**SERVICE BULLETIN NUMBER 1997-004****ACTION REQUIRED**

**TO:** ALL OPERATORS OF HALL SKI LIFT AND VON ROLL TRAMWAYS 2/3/4-PASSENGER CHAIRLIFTS

**SUBJECT:** FAILURE OF CHAIR HANGER - RECOMMENDED CORRECTIVE ACTION

WELDING PROCEDURE  
CHAIR HANGER ASSEMBLY  
INSTALLATION OF  
REINFORCEMENT GUSSET

FIGURE-1  
POSITION OF HANGER ASSEMBLY  
FOR WELDING

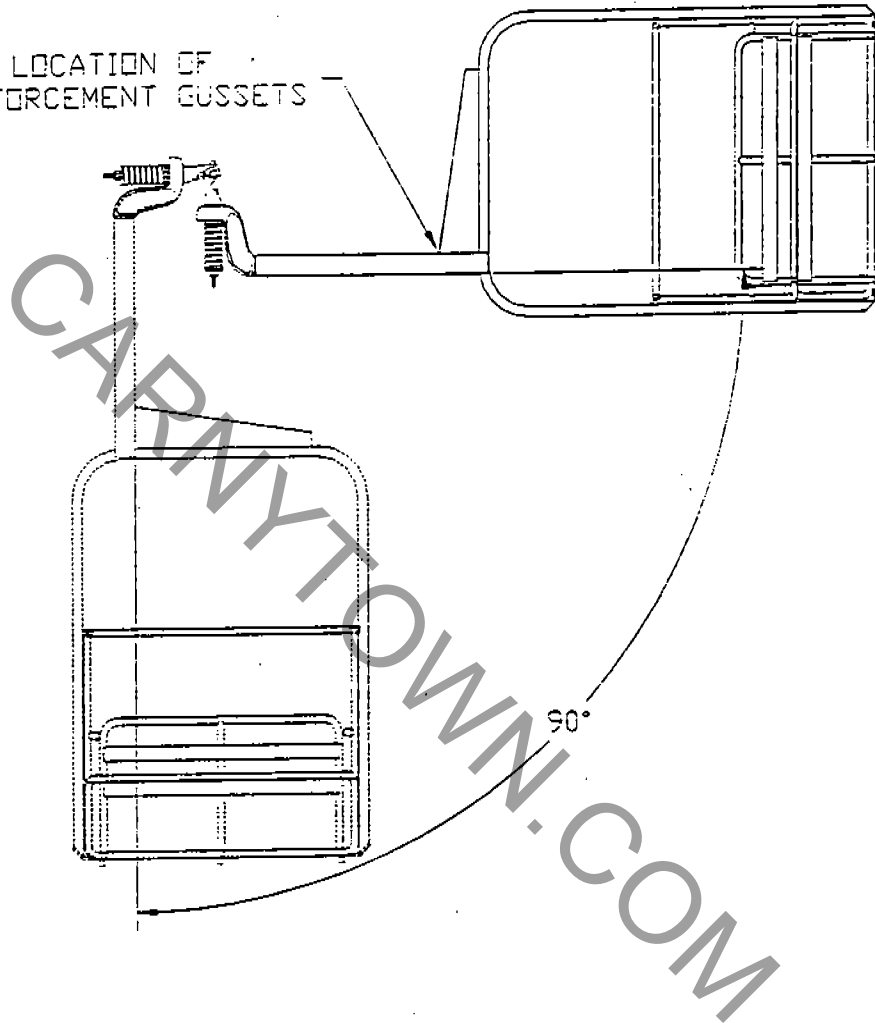
The welds shall be performed in the flat and horizontal position. In order to achieve this position, the hanger assembly may be removed from the chairlift, or alternatively, the grip loosened and the chair rotated 90 degrees towards the inside of the line such that the gusset is pointing vertically up. (see Figure-1)

FIGURE-2  
LOCATION OF GUSSET  
AND TACK WELDS

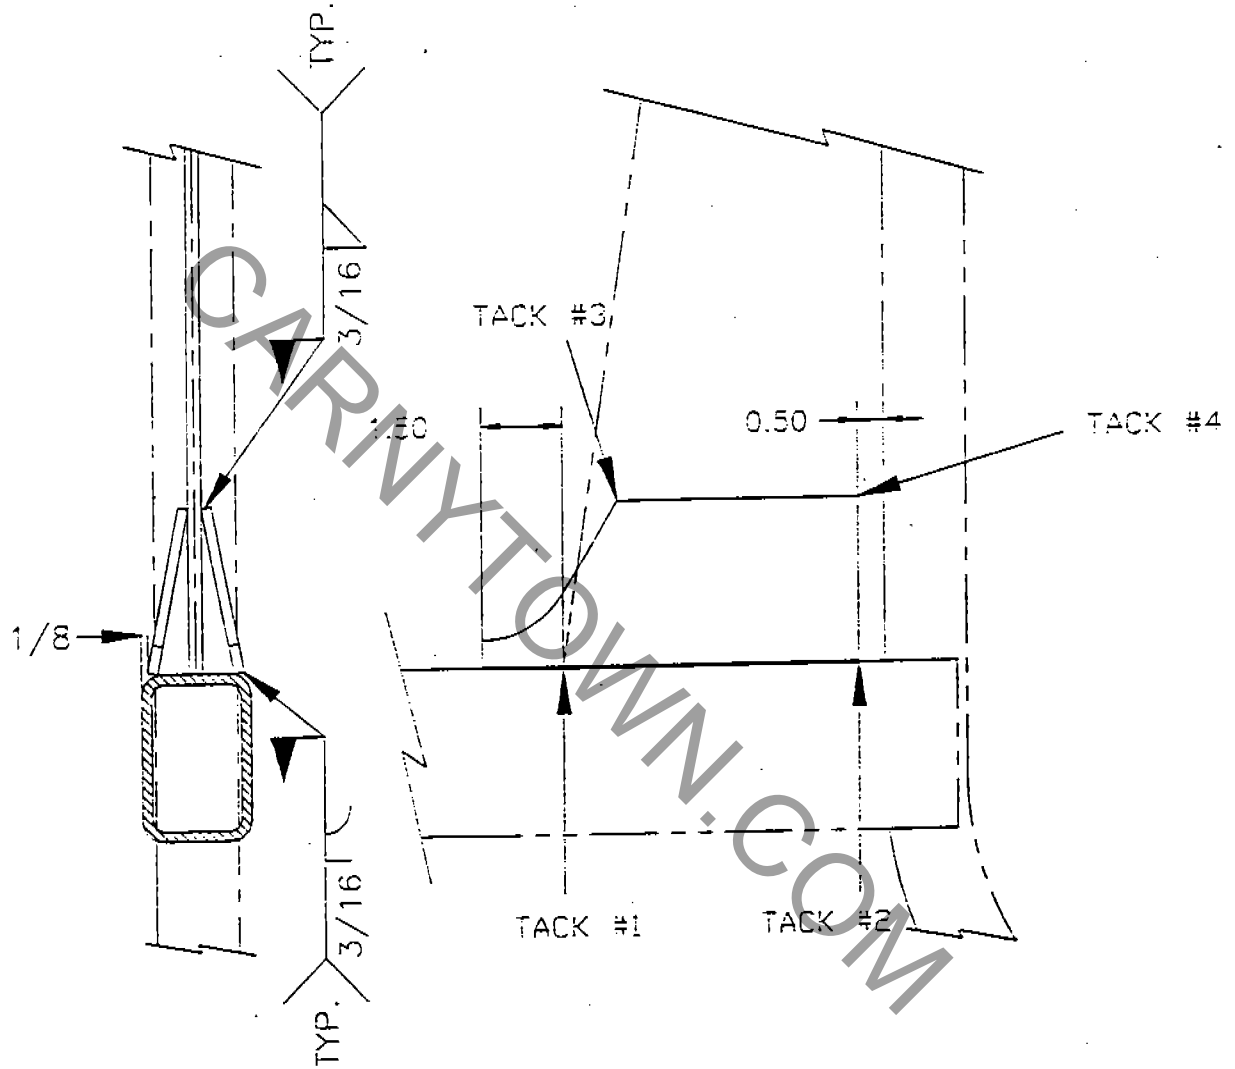
Reinforcement gusset, Von Roll Part Number 100597 shall be placed into position on each side of the hanger assembly (see Figure-2). Four tacks shall be placed as shown using 3/32" E7018 rod.

FIGURE-3  
MEASUREMENT OF  
PRE-HEAT TEMPERATURE

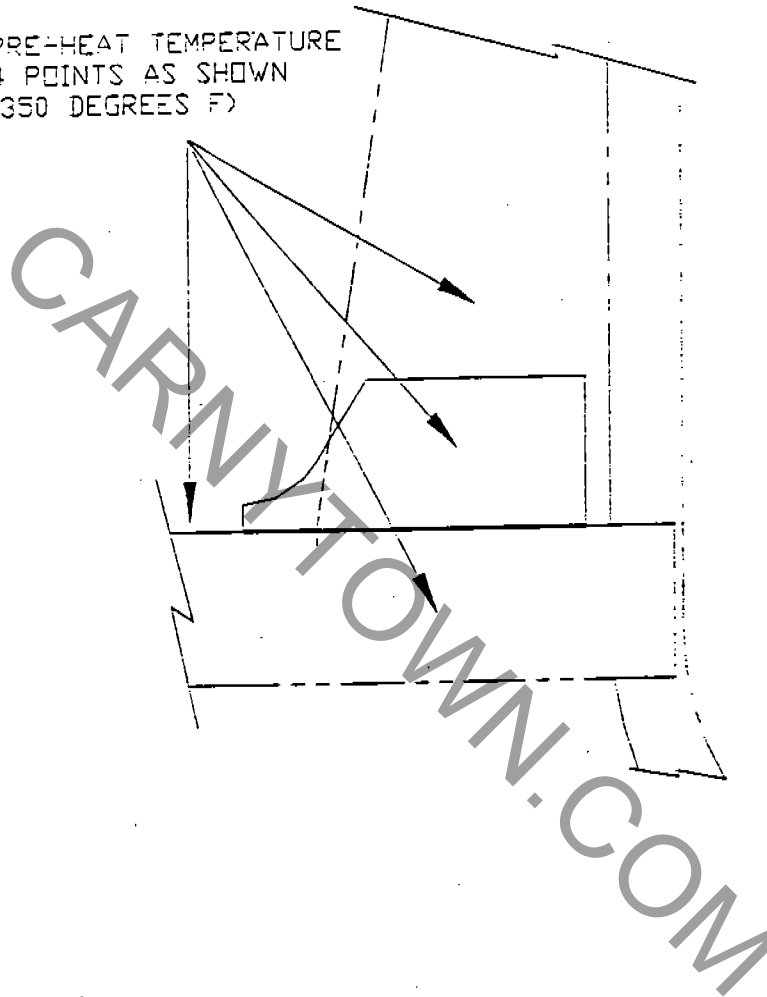
The hanger assembly and reinforcement gusset shall be heated to 350 degrees Fahrenheit in the vicinity of the weld using a torch. A propane torch is recommended to prevent inadvertent over heating (do not heat any area of the hanger tube or gusset beyond 800 degrees Fahrenheit). A 350 degree temperature stick shall be used to determine if assembly has reached the required temperature. Measurements shall be made in the locations shown on Figure-3.

CHECK PRE-HEAT TEMPERATURE  
AT 4 POINTS AS SHOWN  
(350 DEGREES F)

FIGURE-4  
WELD SEQUENCE

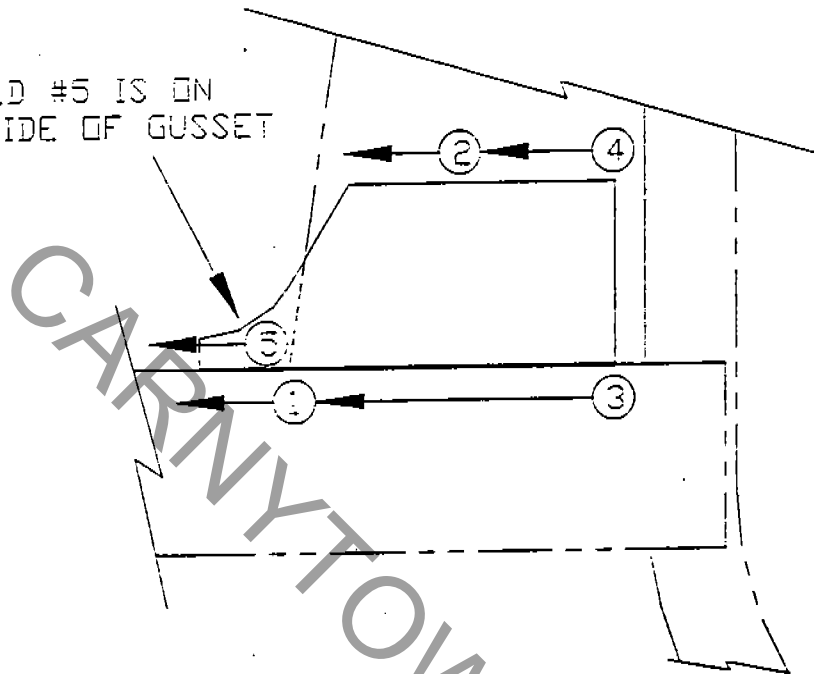
The weld shall be performed as shown on Figure-4. The weld should be started at the location of tack #1 and proceed towards the end of the reinforcement gusset. The weld should then be placed beginning midway between tack #3 and tack #4 and proceed in the direction of tack #3. The weld should then be placed beginning at tack #2 and proceed towards tack #1. The weld should then be placed beginning at tack #4 and proceed towards tack #3. After completing all welding on the outer surface of the reinforcing gusset, a pass is made on the upper 1-1/2 inch of the inside of the gusset. This weld should continue to the end of the gusset and wrap around the end of the gusset.

WELD #5 IS ON  
BACK SIDE OF GUSSET

Figure (1)  
Lead-In Guide Modification

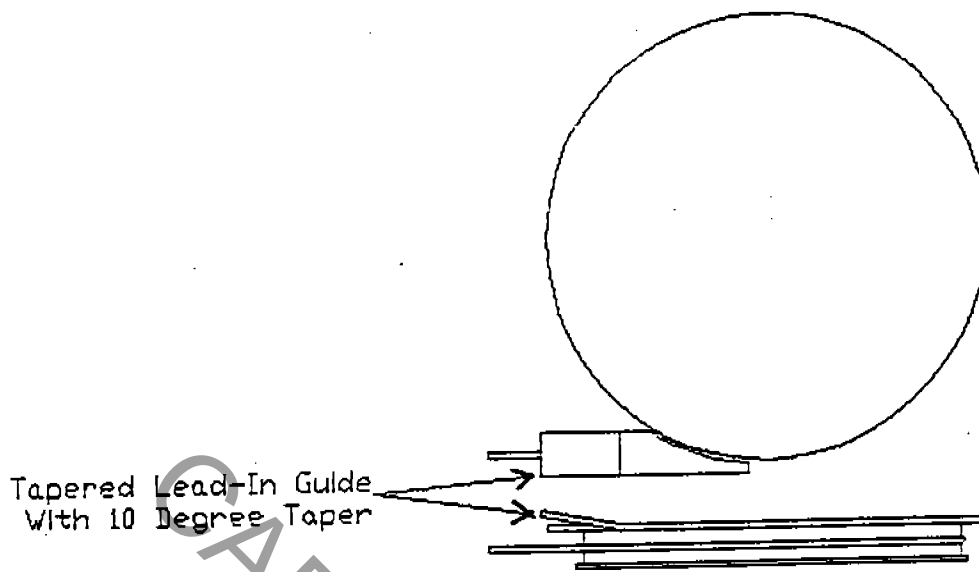
On chairlifts where there is a history or evidence of impact of the chair on the terminal support pedestal, guides must be placed leading into the support pedestal such that a chair approaching the terminal will be gently deflected away from the support structure. When placing guides, it is important to verify proper interface of the chair with the guide as the chair is swung both laterally and longitudinally. **On some existing chairlifts, the existing guides may not prevent chair contact with the terminal support pedestal. If this condition is observed, the guide must be re-positioned or another guide added to prevent the chair from** ~~contacting the support pedestal.~~ *shall* The guide ~~should~~ have an angle from the longitudinal axis of the lift of no more than 30 degrees and shall extend far enough in front of the terminal that a chair cannot get caught on the end of the guide as it approaches the terminal under the most severe combination of lateral and/or longitudinal swing.

On chairlifts where there is a history or evidence of impact of the gooseneck on the bullwheel flange as the grip/gooseneck enters the bullwheel (occurs if chair is swung outward from the lift centerline as the grip/gooseneck approaches the bullwheel), provisions ~~must be~~ *shall* incorporated to provide a gentle transition onto the bullwheel flange. This ~~could include~~ *shall* an angled plate (no more than 10 degrees from the horizontal) which is level with the flange of the bullwheel. If a chair is swung outward as it approaches the bullwheel, it will contact the angled plate which pushes the gooseneck downward before it comes into contact with the bullwheel flange. Please refer to figure (1):

**Figure (2)**  
**Welding Position**

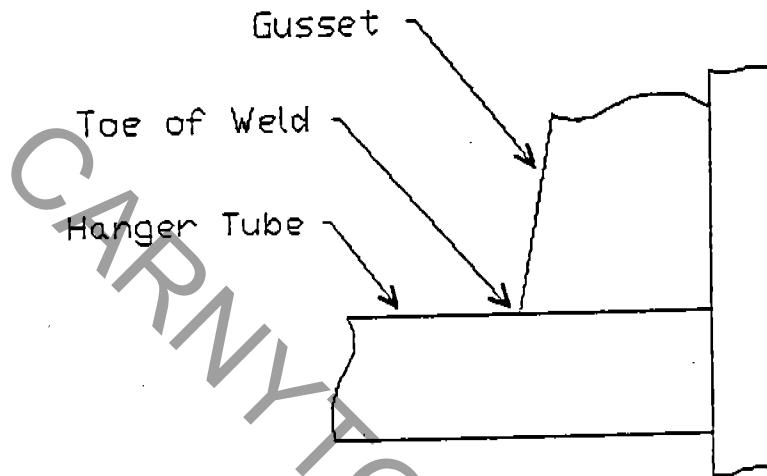
- The weld shall be performed in a flat position (see figure 2), beginning at least two inches from the toe, and continuing towards the toe and around the other side of the gusset without interruption (see figure 3). **Do not stop or interrupt the weld at the toe.** *shall*
